# REGIONAL REVIEW FINDING

**ARC REVIEW CODE:** R1303041

**Name of Proposal:** CSX Intermodal Facility – Track Expansion

**SUBJECT:** **Transportation Division Review of DRI # 2326**  
Project: CSX Intermodal Facility - Fairburn  
County: Fulton  
Location: 6700 McLarin Road; Fairburn, GA  
Analysis:  
Expedited ☒  
Non-Expedited ☐

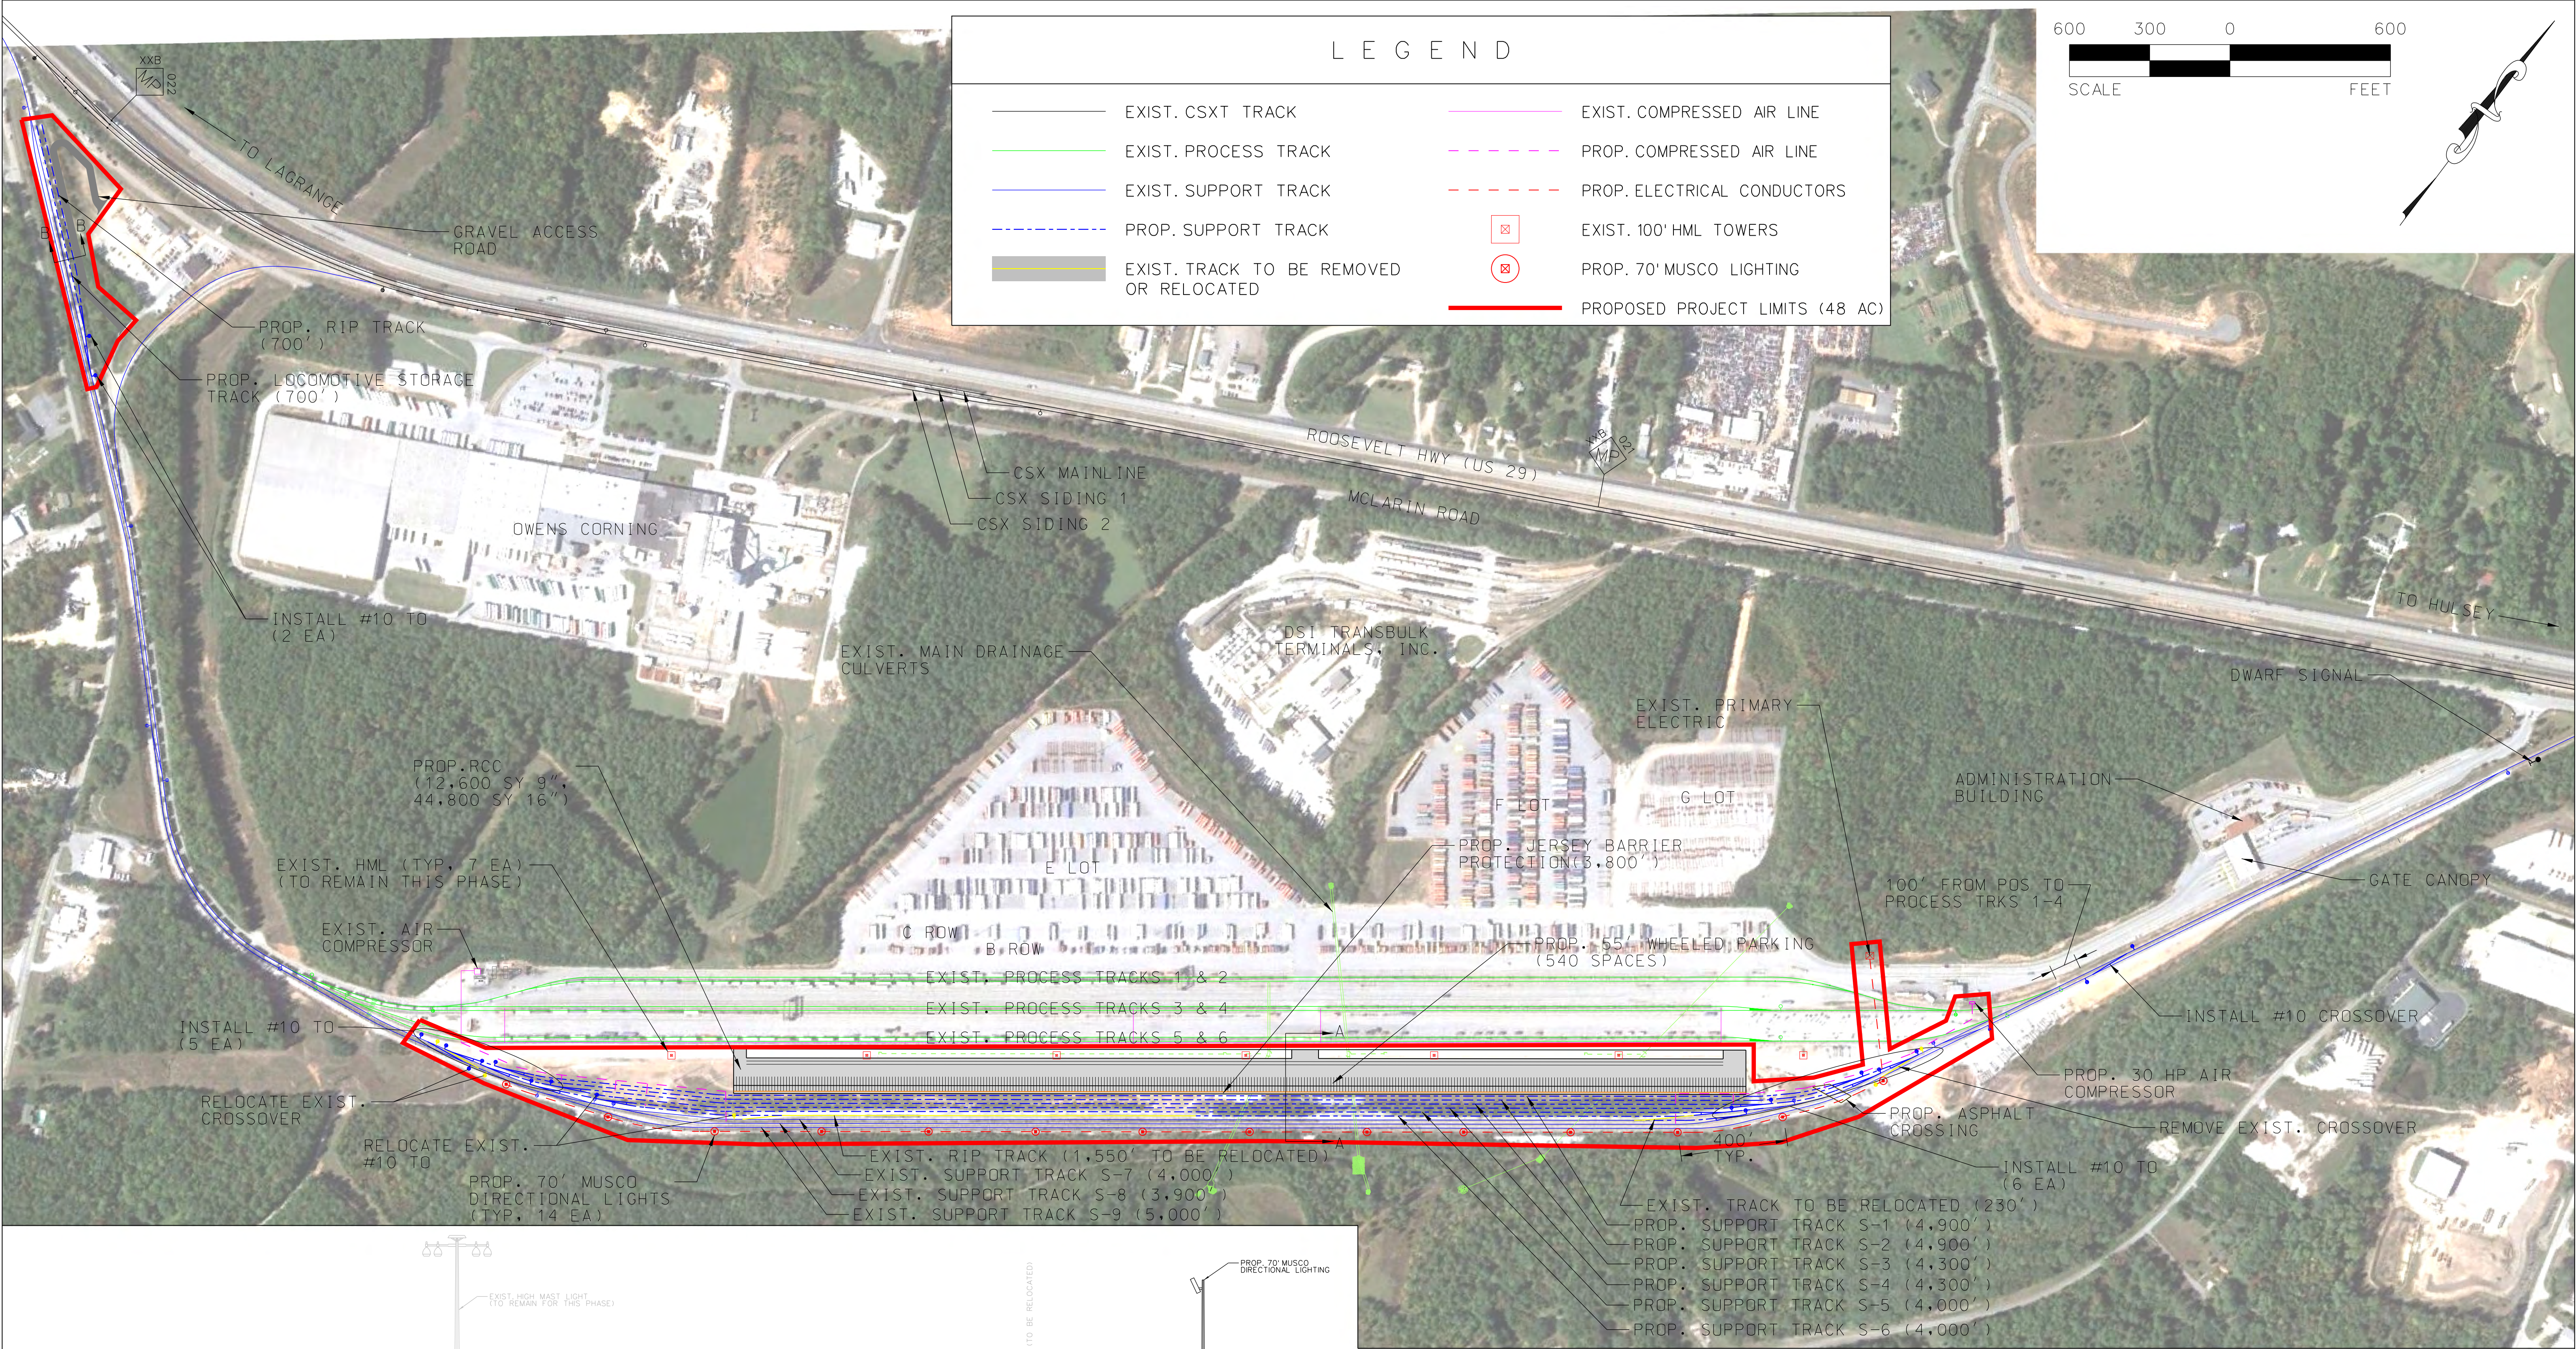
The USGS coverage for the project area shows two blue line streams on the project property: the headwaters of Line Creek and an unnamed tributary of Line Creek. The existing rail facility crosses both streams, which have been piped under the existing facility. Based on the submitted plans, the proposed expansion will be built between two existing rail areas where the streams are already piped. No increase in piping is indicated.
